Detroit
Edison

September 20, 1985
RC-LG-85-0004

Subject: Revisions to Inservice Testing Program for
Pumps and Valves

Revisions to the Fermi 2 Inservice Testing Program for pumps and valves are provided in Attachments 1 and 2 in accordance with 50.55a(g)(5)(iii). These revisions are to be incorporated into Revision 2 of the IST Program (Reference 2) and complement similar program revisions previously submitted via References 3 and 4. The enclosed Program revisions are being implemented to support the Fermi 2 startup program.

Figure PR-6 Two Pump Acceptance Criteria

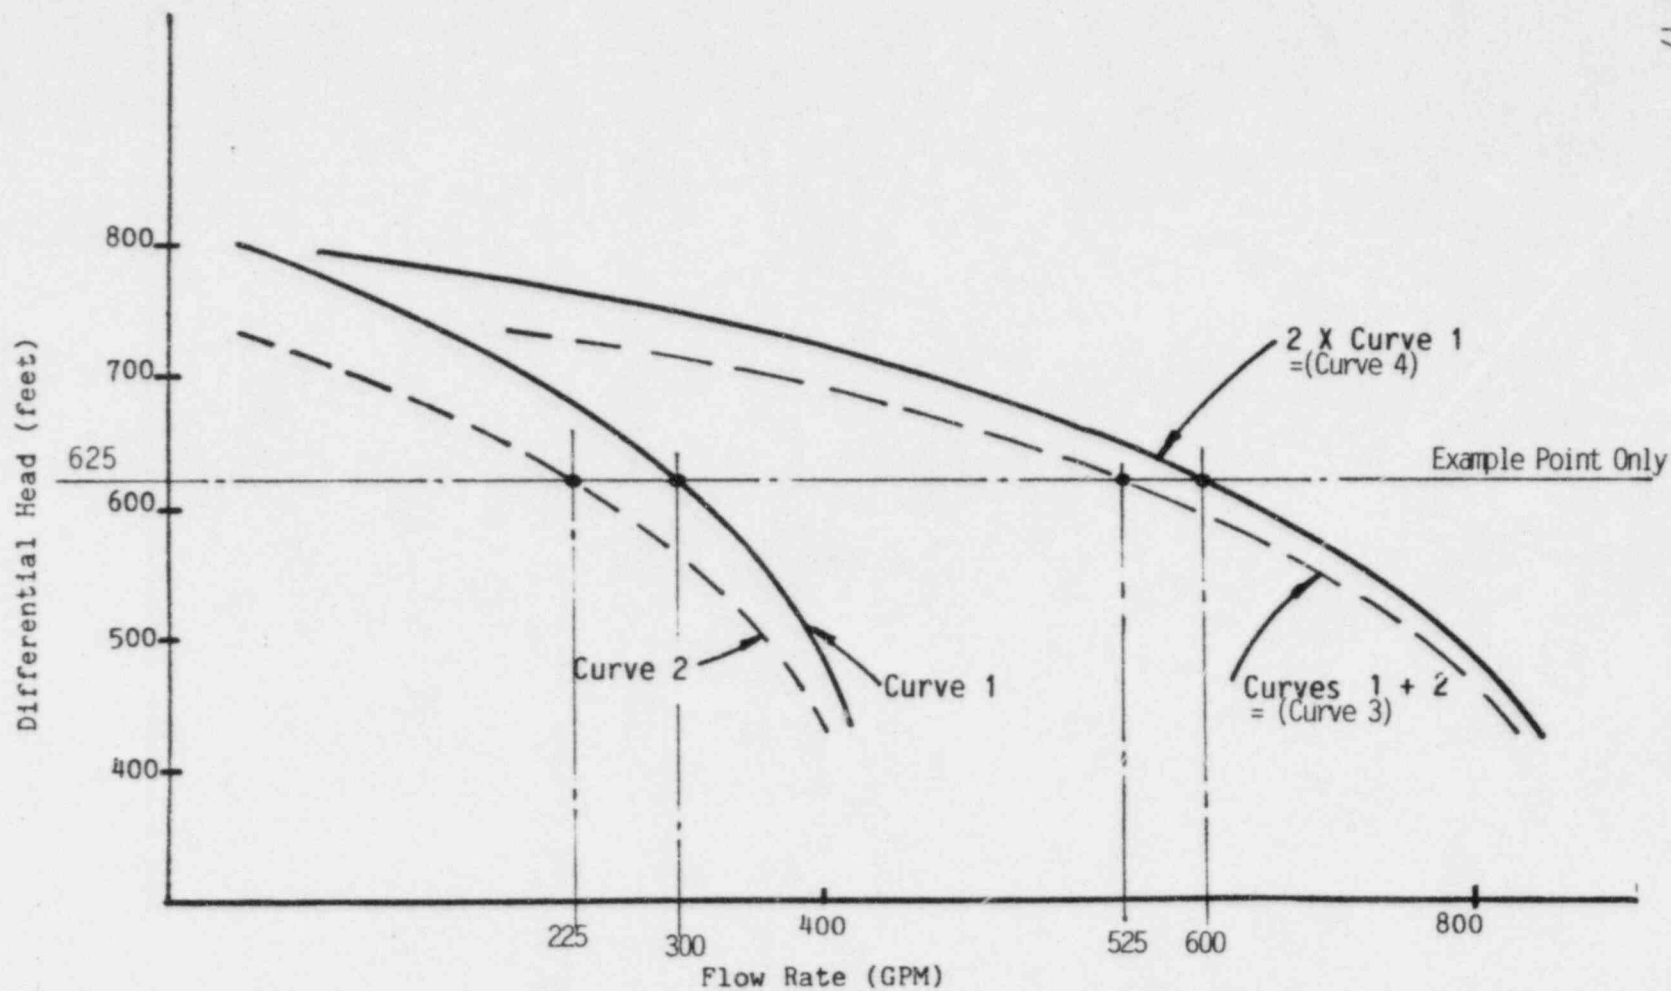
BASIS FOR RELIEF: Each core spray division is designed to have two pumps operating in parallel in accordance with Technical Specification Paragraph 3.5.1.a. If one pump is determined to be inoperable, then the division is declared inoperable. Due to this two pump design, the system configuration does not allow for single pump testing. The throttle valves (E21-F015A and B) on the test lines for each core spray division tend to close due to reduced flow during one pump operation. Consequently, both pumps in each division must be running during performance operability testing.

Detroit Edison proposes measuring flow rate and differential pressure while both pumps in each division are operating. Also, acceptance criteria have been developed which are more restrictive for flow rate and differential pressure than the criteria given in Table IWP-3100-2. The reduced ranges compensate for the loss in sensitivity from the single pump test to the two pumps in parallel test.

The reduced ranges are based on an evaluation of each pump curve. Curve 1 in Figure PR-6 represents the pump curve (differential pressure, P, versus flow rate, Q) for a normally operating pump. Curve 2 represents the performance of a similar pump but at a degraded state (0.9 P versus Q). For a given differential pressure, the flow rate from Curve 1 was added to the corresponding flow rate from Curve 2. This summation produces Curve 3 which reflects the parallel operation of two pumps, one operating normally (Curve 1) and one operating in a degraded state (Curve 2). Comparing Curve 3 to Curve 4, which reflects two normally operating pumps, a new acceptance criteria is

determined. Because of instrument error limitations, the upper alert and required action ranges given in Table IWP 3100-2 will be retained.

ALTERNATE TESTING: Flow rate will be set to a reference value and differential pressure will be measured while both pumps in each division are operating. The following acceptance criteria will be applied:

<u>Acceptable Range</u>	<u>Alert Range</u>		<u>Required Action Range</u>	
	Low Values	High Values	Low Values	High Values
0.96 to 1.02 Pr	0.94 to 0.96 Pr	1.02 to 1.03 Pr	0.94 Pr	1.03 Pr
